**FINAL DRAINAGE REPORT
FOR
STERLING RANCH FILING NO. 2**

Engineering Review

**May 2020
Project No. 25188.01**

PCD File No. SF-1820 **SF-20-015**

Hydrologic Soil Group—El Paso County Area, Colorado

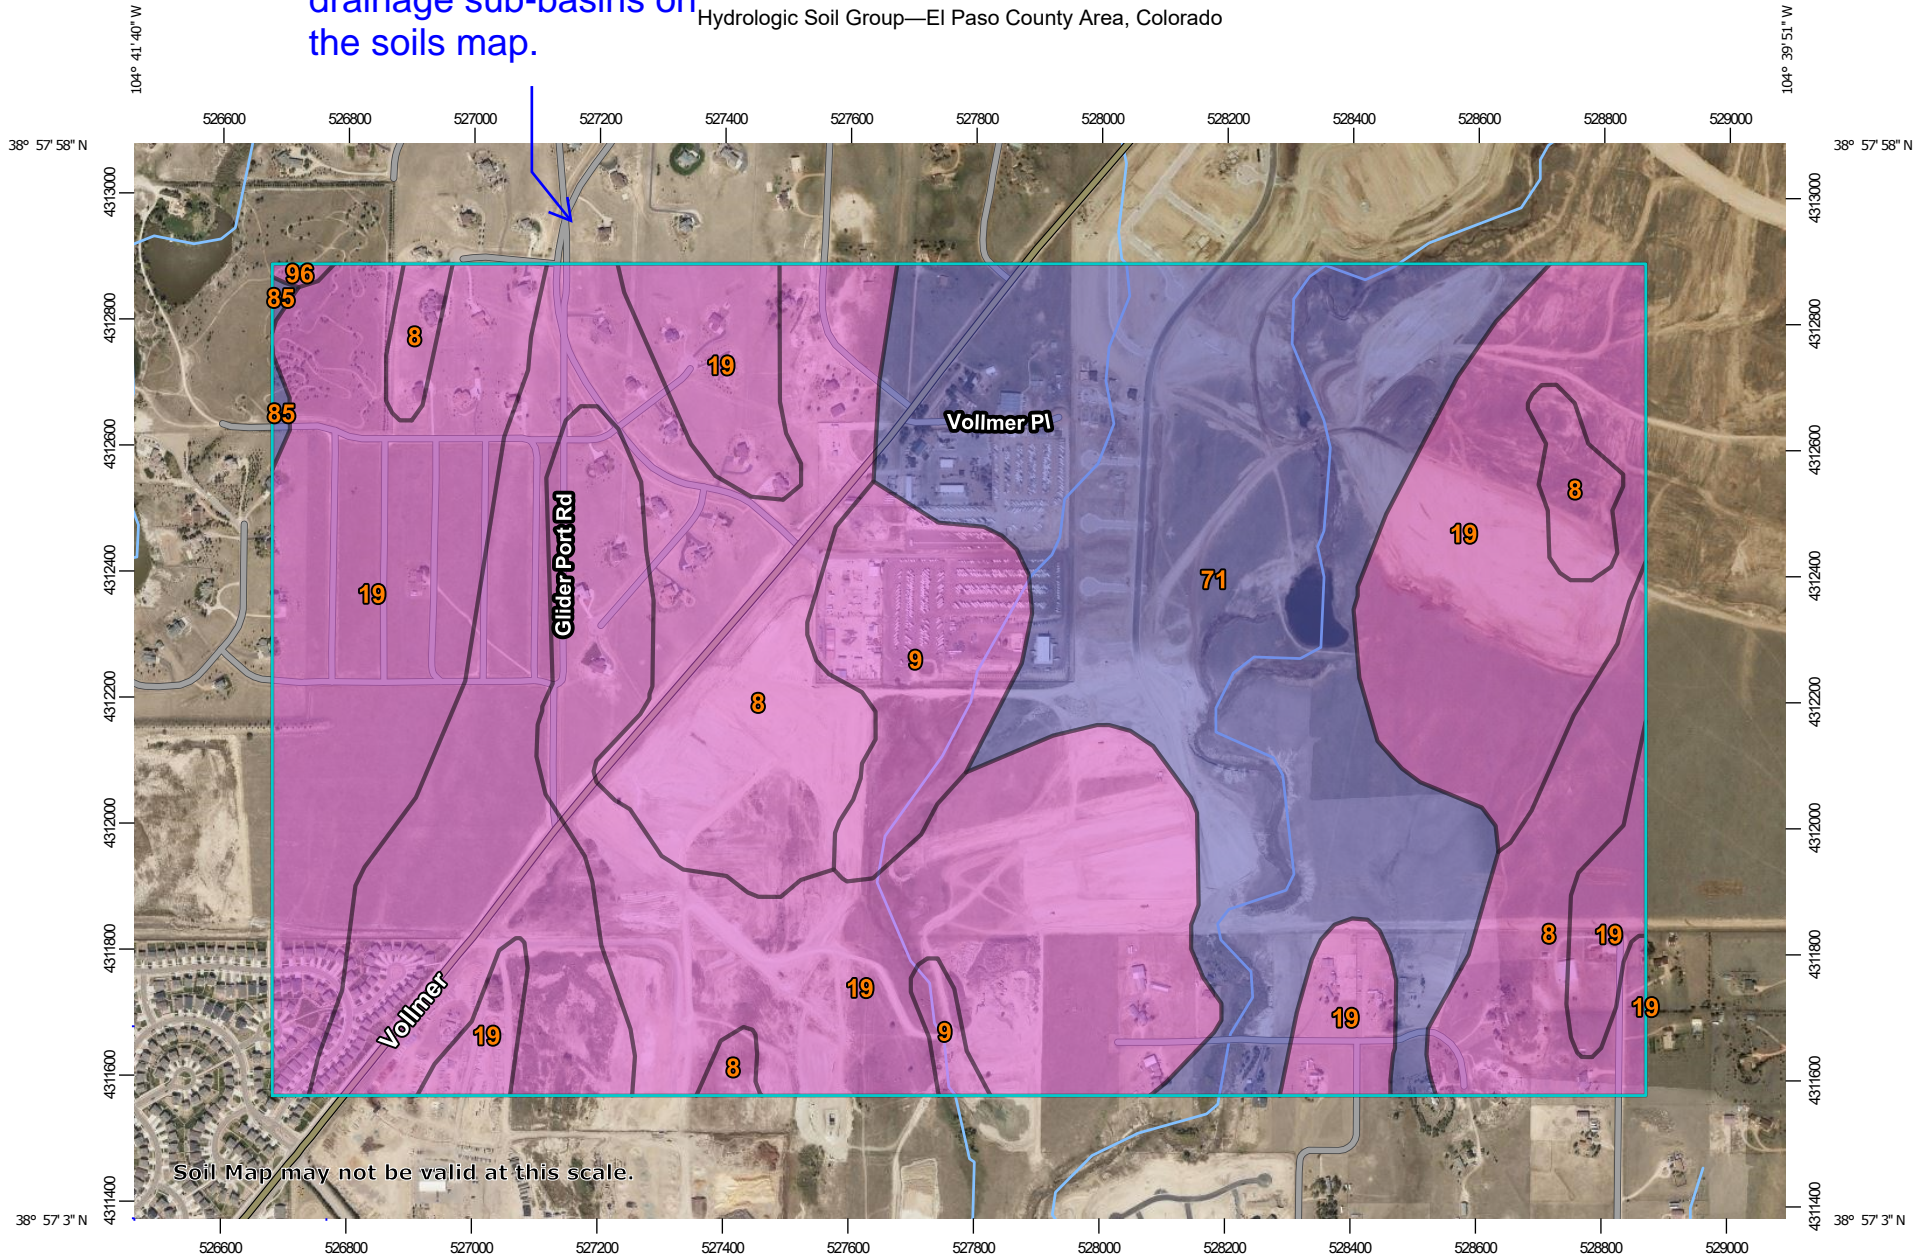
Show overlay of applicable drainage sub-basins on the soils map.

SAND CREEK DRAINAGE BASIN PLANNING STUDY
 PRELIMINARY DESIGN PLANS

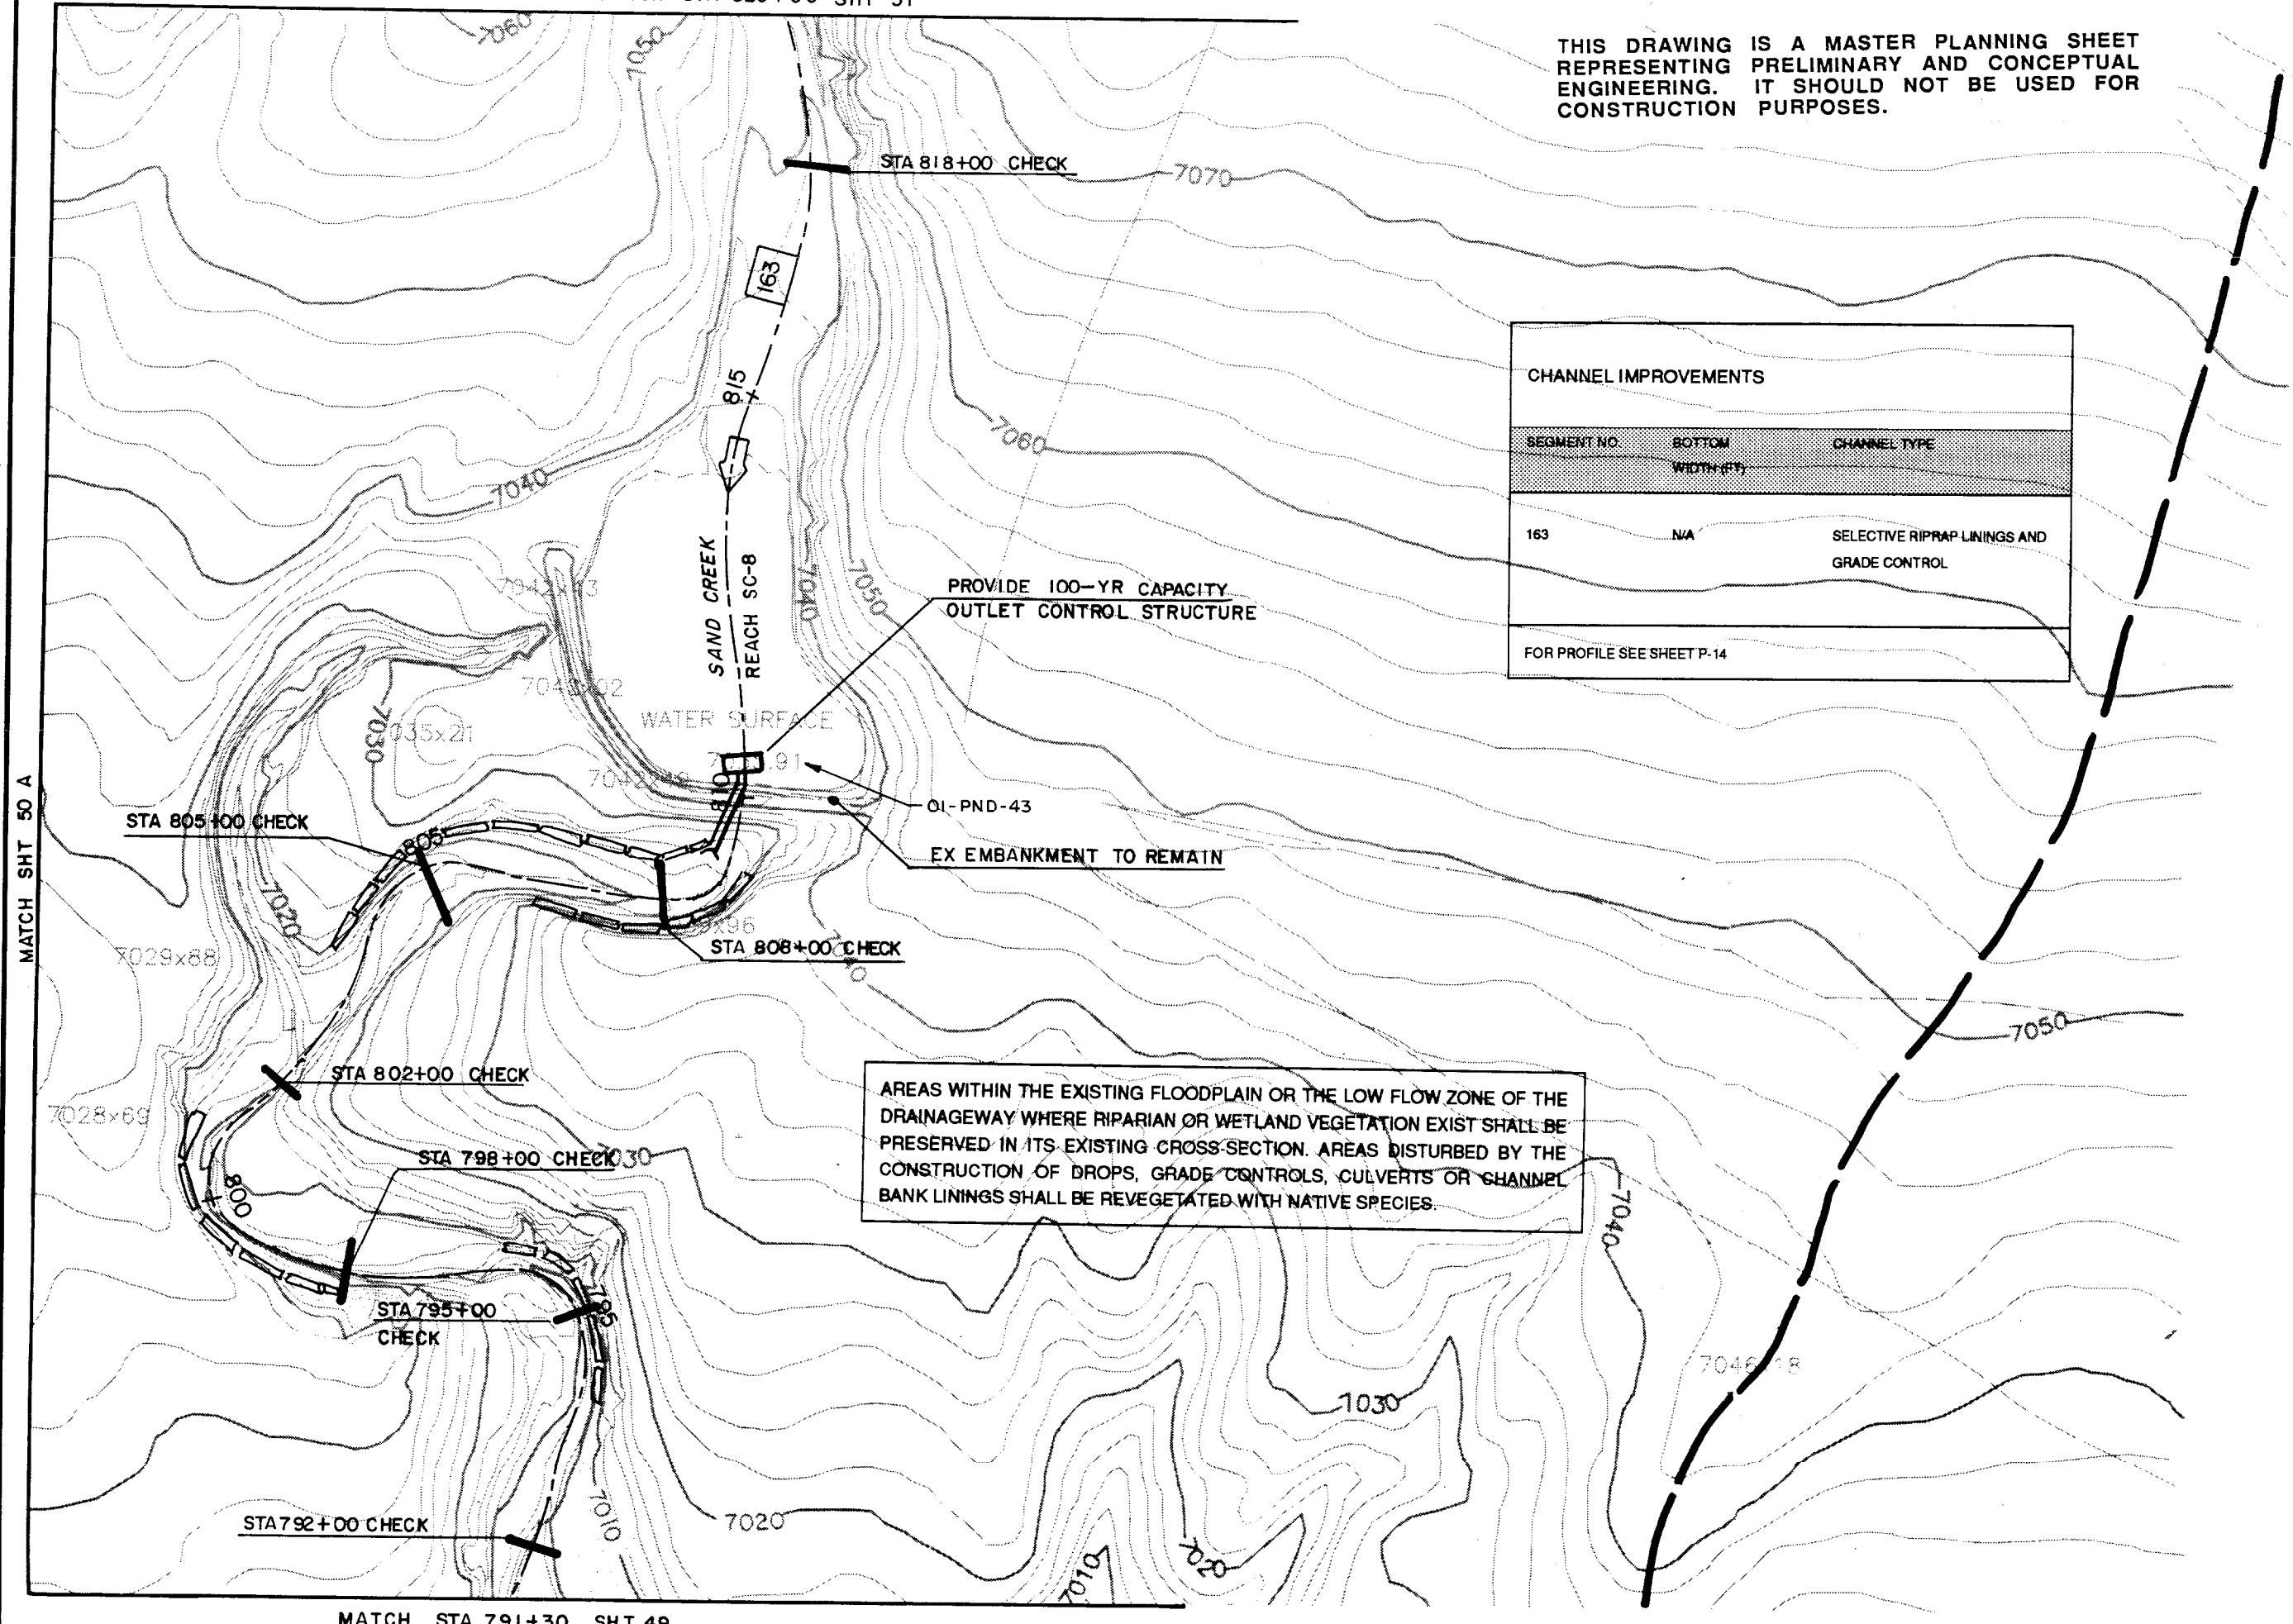
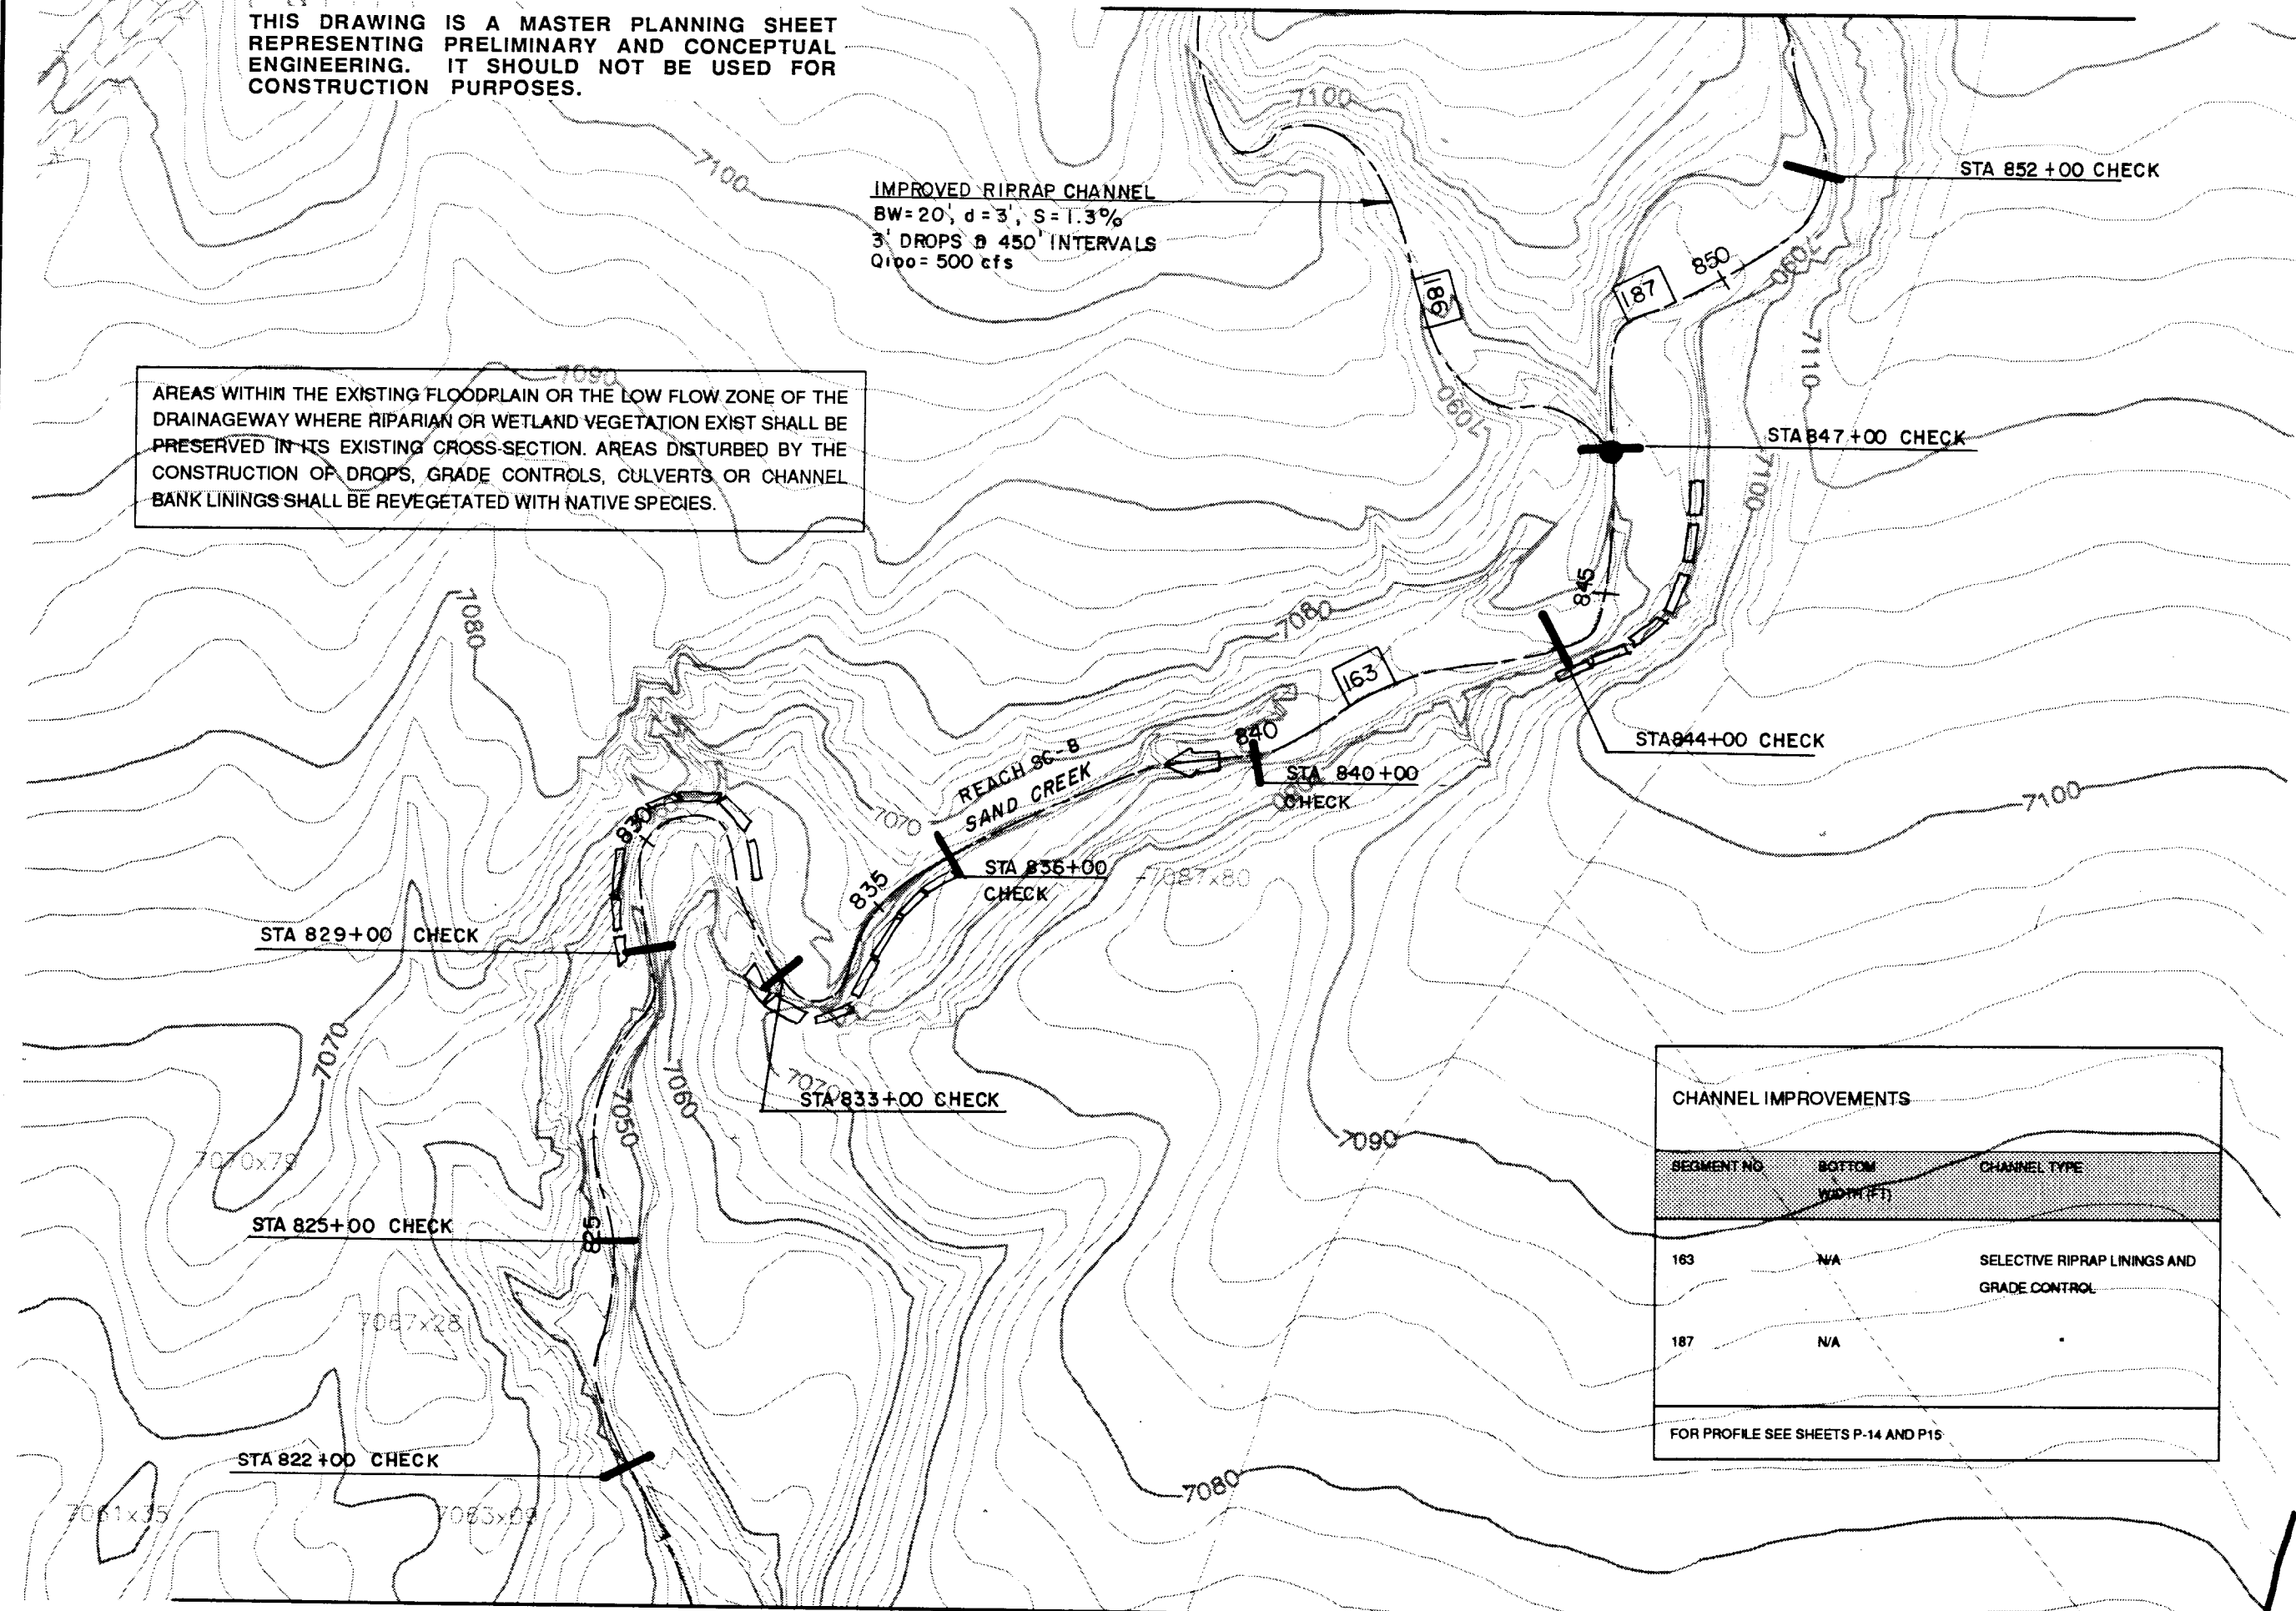
Include DBPS plan sheets 48 and 47
